PCB VERIFICATION SAMPLE LOCATIONS

FORMER EMPIRE ELECTRIC SITE NO. 224015
CONTRACT # D007630
BROOKLYN, NEW YORK

SHEET # 1

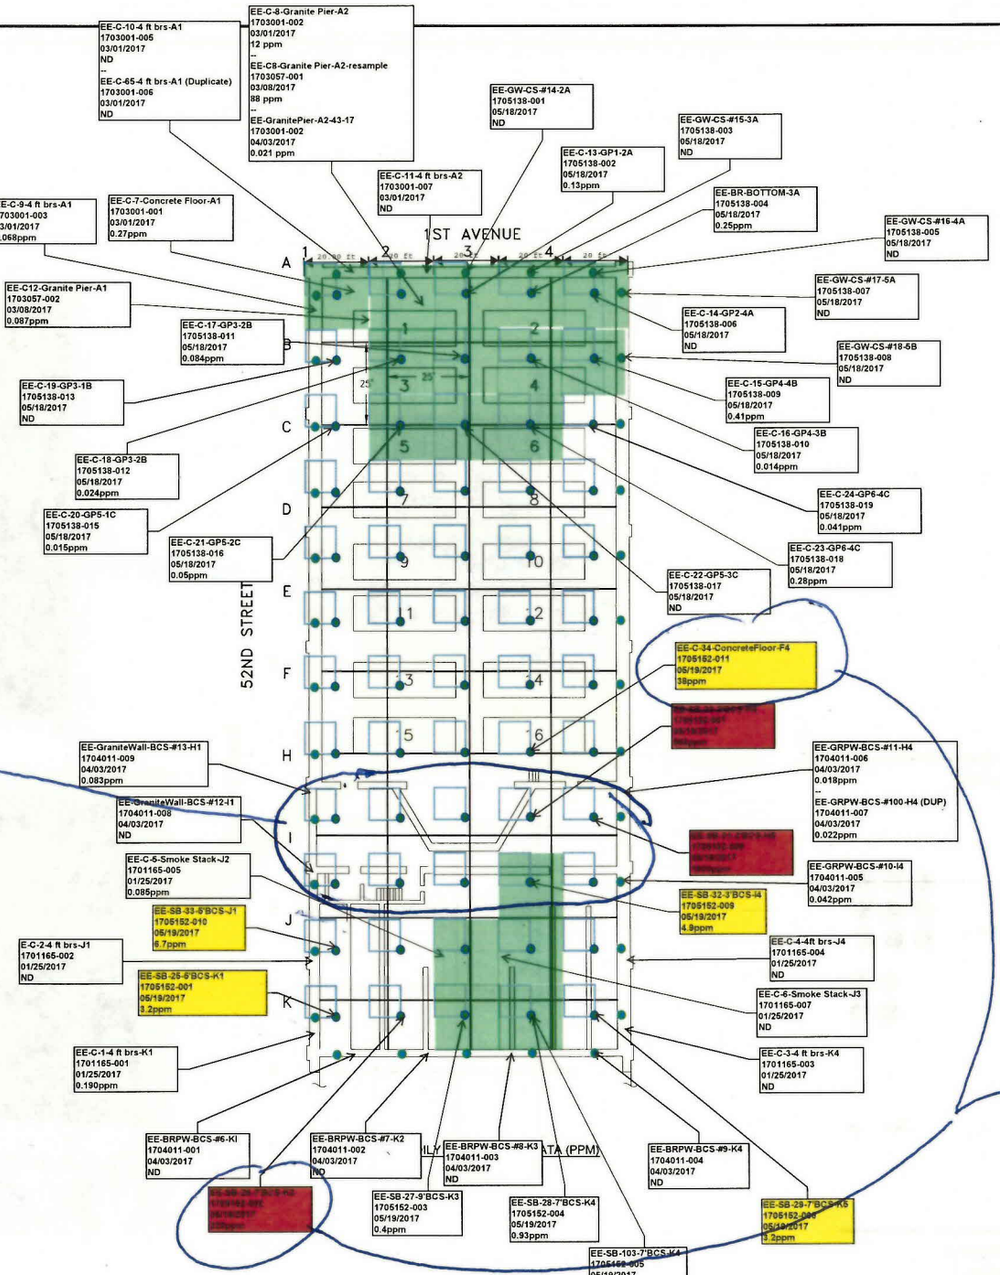
WHY DO THE CHARACTERIZATION SAMPLES EXTEND ALL THE WAY ACROSS? SHOULDN'T THEY JUST BE FOCUSED IN THE LOCATIONS WITH EXCEEDANCES?

WHAT ABOUT THESE LOCATIONS? BECAUSE ULTIMATELY LOOK AT 10PPM WITH A CAP FOR HIGH OCCUPANCY, SO DO THESE AREAS NEED MORE CHARACTERIZATION?
